**** TECHNICAL INFORMATION NOTICE ****

DATE: April 29, 2025
TO: Mitsubishi Motors US & Puerto Rico Dealer Parts & Service Managers
RE: Potential Tow Hitch Vibration Noise
TIN NO. TIN-25-66-002

2025 Outlander / MZ315484 – Tow Ball & Mount

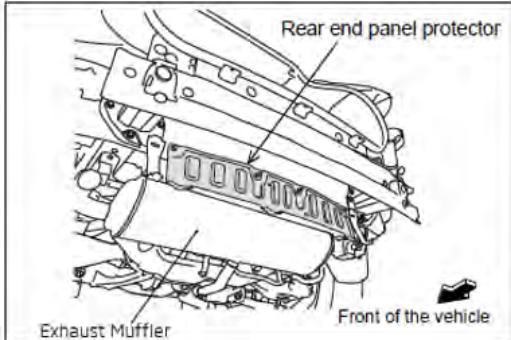
To inform dealer technicians of an installation procedure change for the MZ3153254 Tow Hitch on 2025MY Outlander vehicles. The update ensures proper installation and prevents potential damage or vibration issues that may result from interference with the rear end panel protector.

During installation, technicians may find the rear end panel interferes with the tow hitch installation. Please do not attempt to trim the sheet material and reinstall it, since this can lead to sharp edges and potential vibration noise.

Certain kits were distributed without the latest installation instructions specific to the 2025MY Outlander. The updated instructions note that the removed rear end panel protector will not be necessary, as the tow hitch will provide protection in its place.

- Please use the QR code below to view the most current installation instructions for the MZ3153254 Tow Hitch. Follow the updated instructions for proper tow hitch installation on 2025MY Outlanders.
